PCN-20220725 TE0820-04 to TE0820-05 Hardware Revision Change

Company	Trenz Electronic GmbH
PCN Number	PCN-20220725
Title	TE0820-04 to TE0820-05 Hardware Revision Change
Subject	Hardware Revision Change
Issue Date	2022-08-04

#17 Added power diagram page.

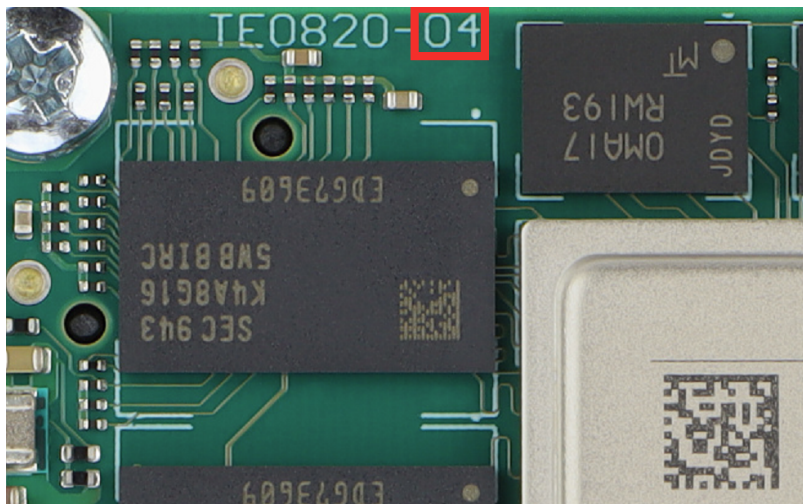
Type: Documentation Update

Reason: Power documentation improvement.
